**AN ORDINANCE AMENDING THE RAMLIN ROSE  
PLANNED DEVELOPMENT TO AUTHORIZE A NEW 70-SPACE PARKING  
LOT AND ASSOCIATED IMPROVEMENTS FOR PROPERTY COMMONLY  
KNOWN AS THE PRESERVES AT WOODFIELD, LOCATED AT 4700 ARBOR  
DRIVE**

### **Ordinance Exhibit 3**

Pursuant to staff review of the above-listed documents, it is recommended that any approval be made subject to final plans to be submitted for building permits include the following required revisions:

Sheet No. **C-2** of 5

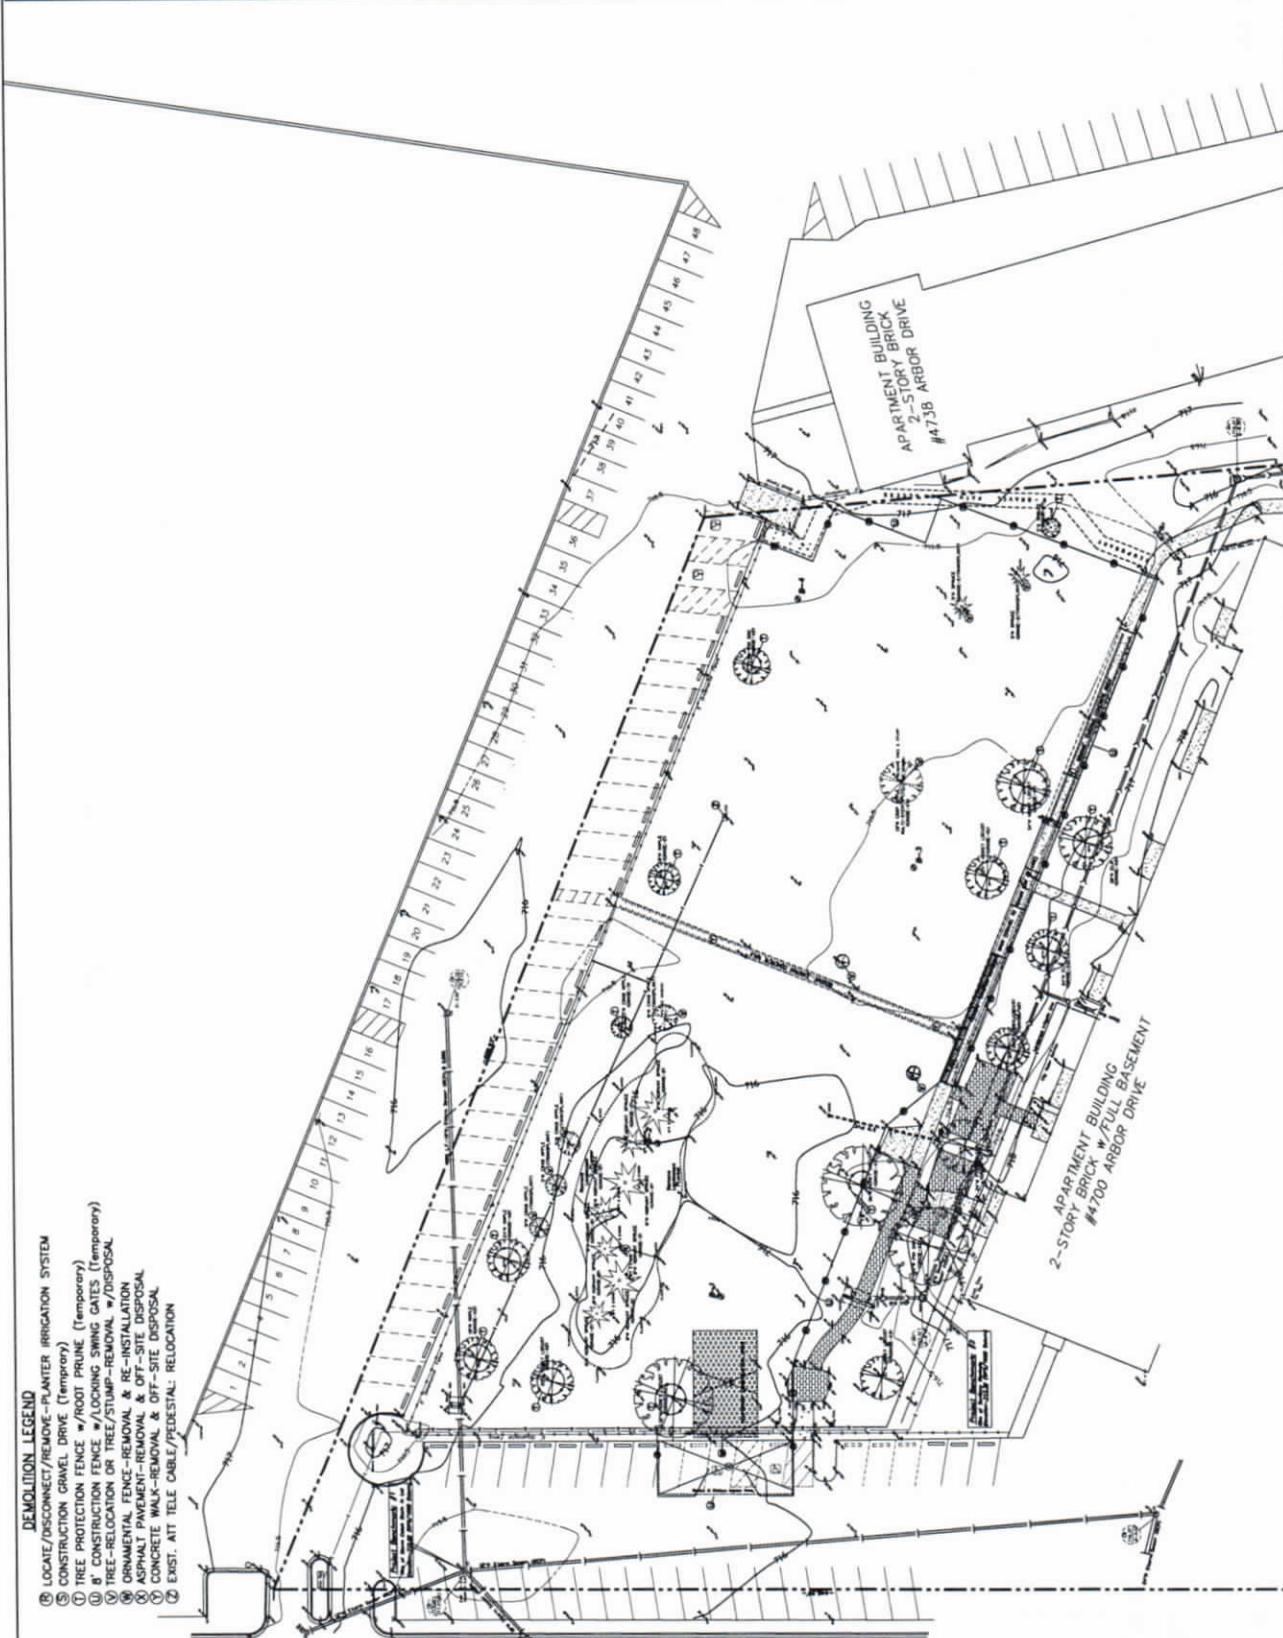
1. Add notes "See C-1, Landscape Wall Detail" and "See Landscape Plan" by Evergreen landscape area.
2. Clarify whether the storm line north of and paralleling the building (and the clean out connections to the building) is existing or proposed. They do not show up on the Alta. Adjust proximity to water line if necessary.
3. Show location of gas line.
4. Will all or some of the ornamental fence stay during construction? Is it intended to remain? Will it be removed and replaced? Please specify on the plans.

**C-3**

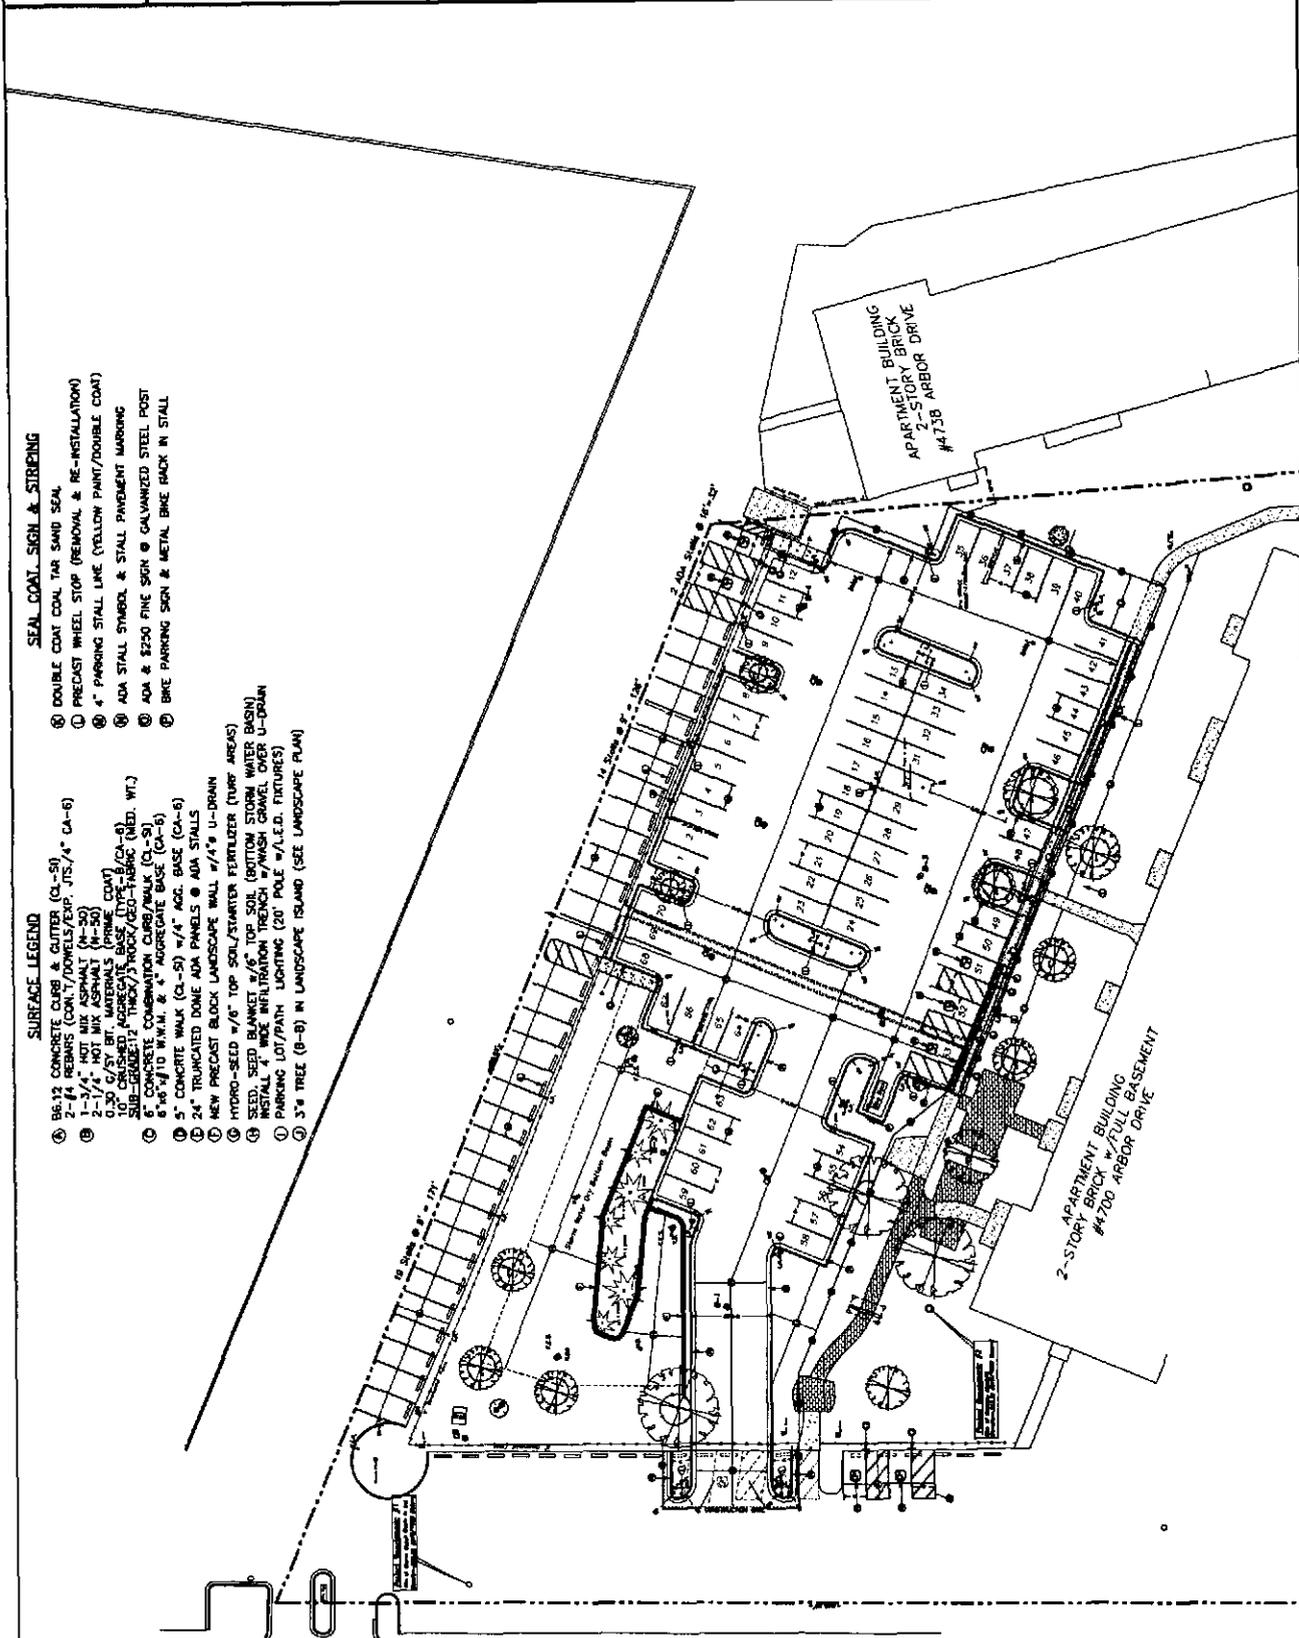
1. Curb omitted in northeast area. Add it to the plans.
2. Access to dumpster. Show ADA walk and break in fence.
3. Restripe parking spaces in the existing parking row west of the improvement from angle to perpendicular spaces.
4. In addition to the striping, sign the space in the parking row north of the project that connects to the proposed sidewalk as "No Parking". Add detail.
5. Add a detail for the bike rack.
6. Show if HMA lifts are N50, IL 19.0 binder and N50, IL 9.5 surface courses.
7. Show ADA ramps at proposed sidewalk locations on the north and northeast side of the parking lot.
8. Curb is not shown to the north of parking stalls 9,10,11 and 12.
9. Show top wall and bottom wall elevations.

Landscape  
Development Plan

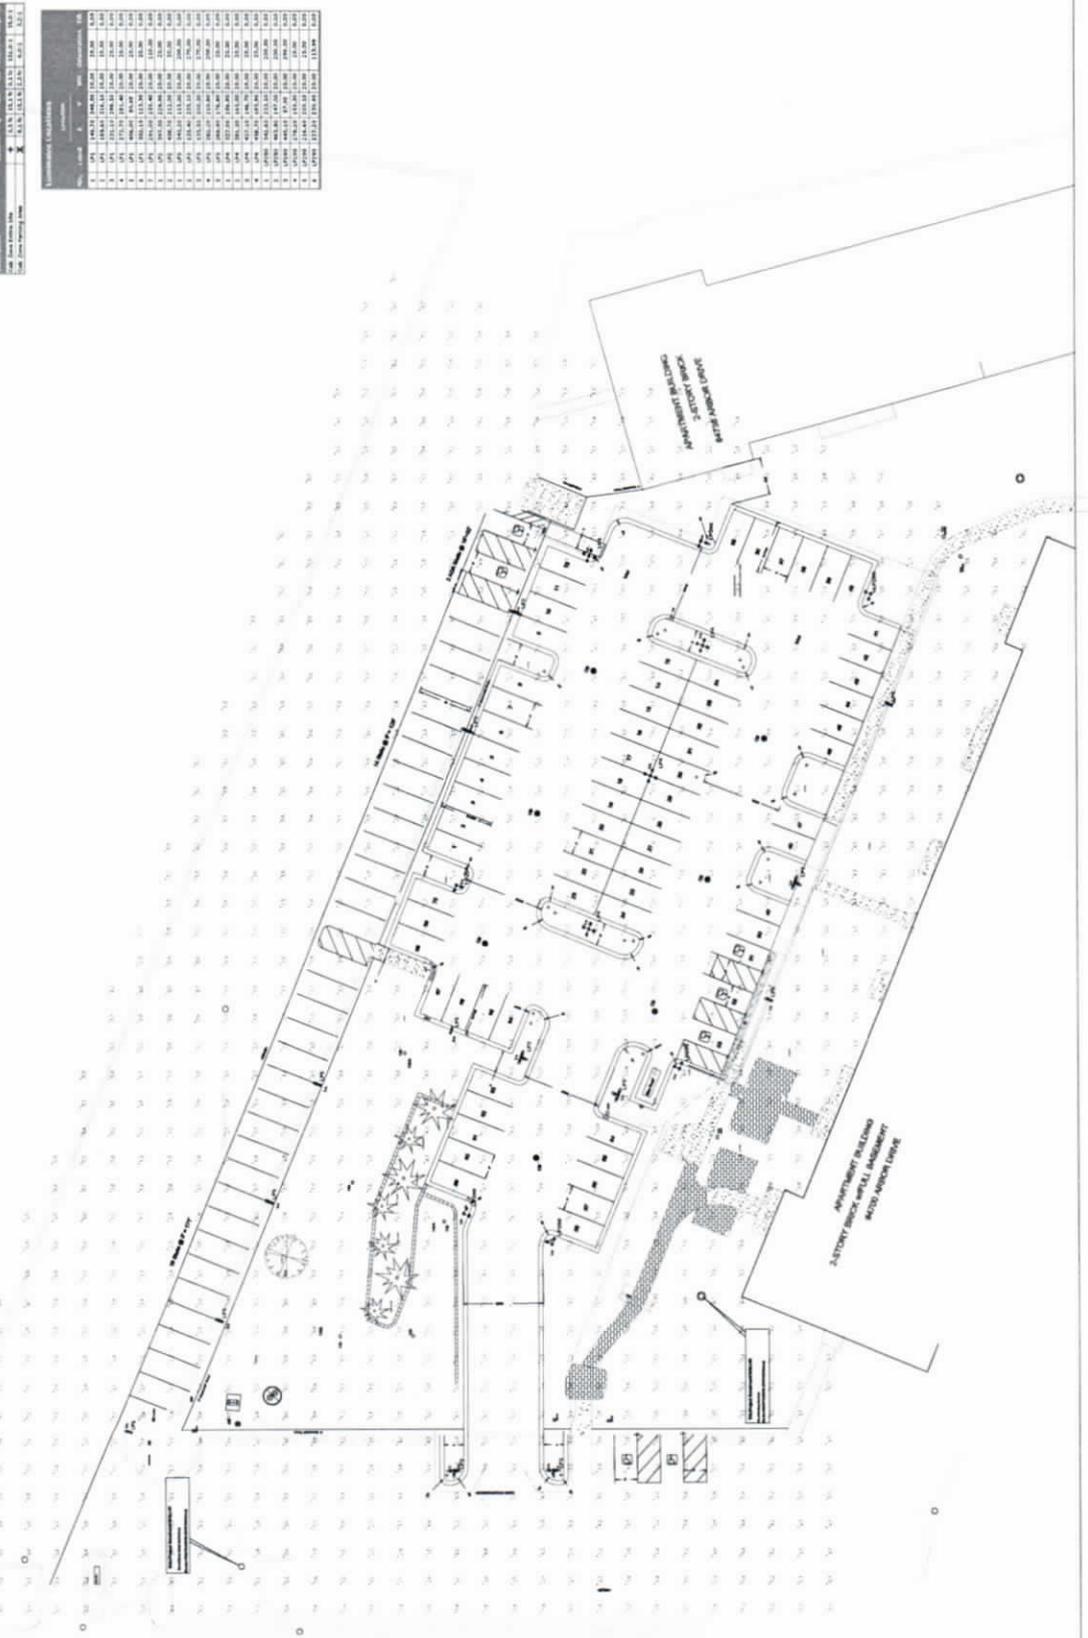
1. Note "Existing Trees to be Preserved" for those trees that will be preserved.
2. Add table with all plant material listed by name, total quantity and size at installation.

3. Proposed landscaping on the east side of the west door is shown in an area where other plans identify existing hardscape walks to remain. Revise.
4. The proposed berms near the building do not align with the proposed grading plan. Grading plan can be revised to note "See Landscape Plan".

5. Add a note that new landscape beds will be spade edged and mulched with 4" of premium shredded hardwood mulch.
6. Remove Chanticleer Pear and Autumn Blaze Maple, replace with one of the following

- Kentucky Coffee tree
  - Burr Oak tree
  - Regal Prince Oak tree
  - London Pine tree
7. There needs to be a maintenance/warranty for the transplanted trees for at least a year

8. Include rain garden/bio swale maintenance plan
9. Add 2 trees north of the rain garden
10. Landscape islands- minimum of 12" topsoil/compost
